UNITED STATES PATENT AND TRADEMARK OFFICE

APPLICATION NO.	FILING DATE	FIRST NAMED INVENTOR	ATTORNEY DOCKET NO.	CONFIRMATION NO.
10/045,017	01/15/2002	Yoshitaka Terao	P56664	7888

Office Action Summary

DETAILED ACTION

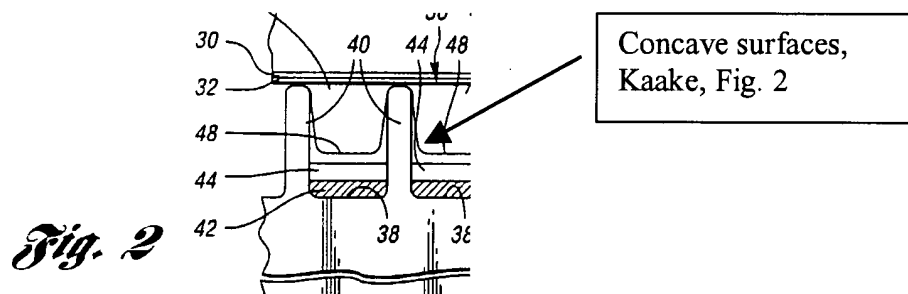
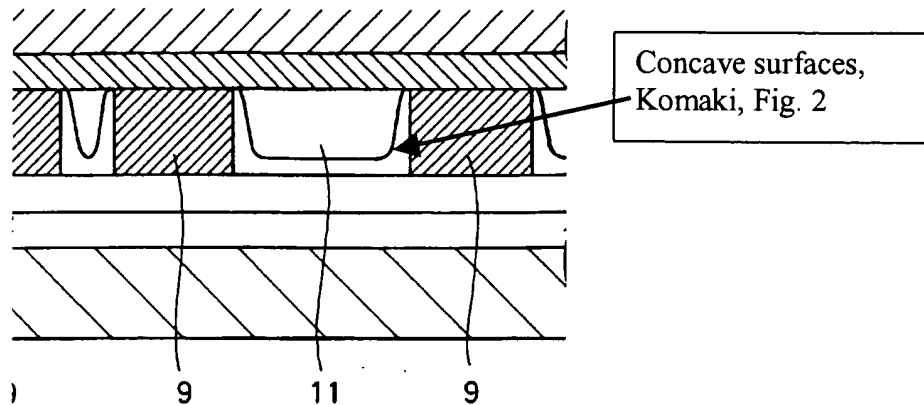
43. Sixth, in response to Applicant's argument concerning claim 10, that the Examiner makes no mention of the partitioned discharge cell being of a certain width to correspond to the color displayed, and that Kaake teaches away from concave surface, the Examiner respectfully directs Applicant to paragraph 27 of the previous Office Action. The Examiner states that Komaki shows "a width of each of the partitioned discharge cells are formed to correspond to a color displayed by the particular portioned discharge cell." Furthermore, both Kaake and Komaki show the discharge cells include concave surfaces (below).
